ADDENDUM NO. 3

Date: August 21, 2023

Issued by: Sacramento City Unified School District

Project: **Project #: 0510-465**
0510-465 CKM/Fern Bacon/Matsuyama/Parkway/Rosa Parks and Sutterville
Security Improvements: Group 2

SHEET NO.
T900

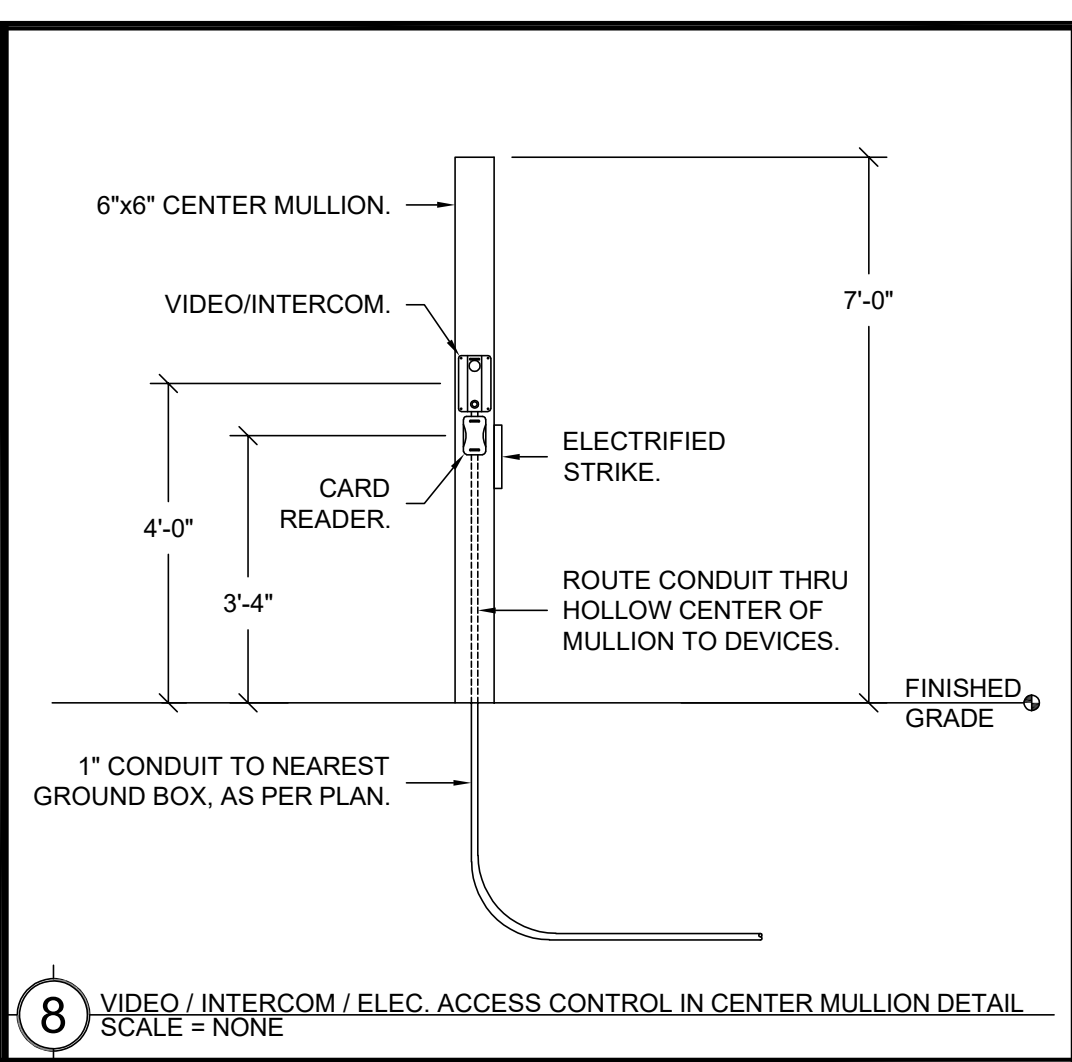
Sheet T900

- Single line diagram updated with new connections per Sheet T200 and T201.
